## **UNITED STATES** DEPARTMENT OF THE INTERIOR

SU	NDRY	ľ	O	<b>FICES</b>	AND	REI	PO	RTS	ON	WELLS
				_

Oil Well X Gas Well	Other	UEC 7	1 2008	8 Well Name a	and No	
2 Name of Operator	Marbob Energy Corpo	OCD-A	RTESIA	Kick 9 API Well No	apoo Federal Com #1	
3a Address	Warboo Energy Corpo	3b Phone No (inclu	de area codes	1111111111		
PO Bo · Artesia, NM			48-3303	30-015-30770 - 10 Field and Pool, or Exploratory Area		
4 Location of Well (Locatage, Sec., T	Wildcat; Mississippian (Gas)					
2094' FSI	11 County or F	Parish, State Eddy Co., NM

## Temporary Abandonment of Wells on Federal Lands Conditions of Approval

(See charts attached)

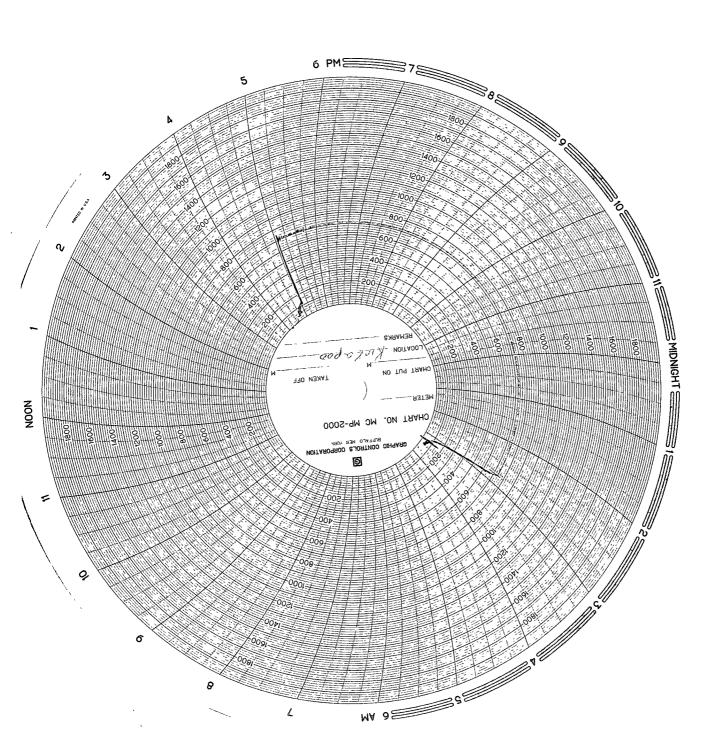
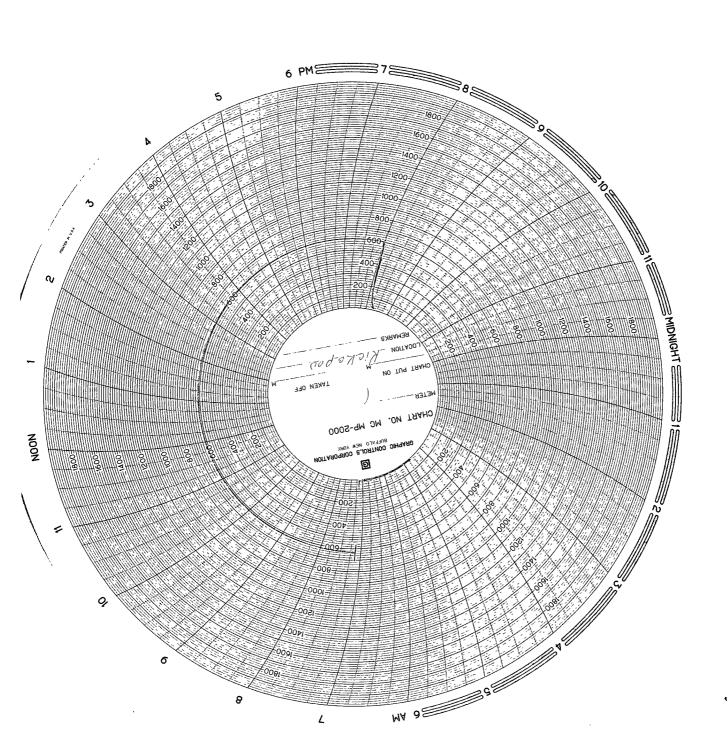
This TA will only be good for one year after that time CIBP will have to be placed within 50 feet of top perf. with cement on top and a MIT ran and

69 the well must be online

witnessed by BLM.	or plans to	r a A must be submitted.		
14. I hereby certify that the foregoing is true and correct				
Name (Printed Typed)				
Diana J. Briggs	litle	Production Analyst		
Signature IAAA AAAAAAAAAAAAAAAAAAAAAAAAAAAAAAAA	Date	December 2, 2008		
THIS SPACE FOR	FEDERAL OR STATE OFFICE	USE		
Approved by /s/ JD Whitlock Jr	Title LPET	Date 17/10/08		
Conditions of approval, if any are attached Approval of this notice does no certify that the applicant holds legal or equitable title to those rights in the swhich would entitle the applicant to conduct operations	subject lease Office \( \begin{align*} FO \\ \exists \exists \]			
Title 18 U.S.C. Section 1001 AND Title 43 U.S.C. Section 1212, make it	a crime for any person knowingly and w	illfully to make any department or agency of the United
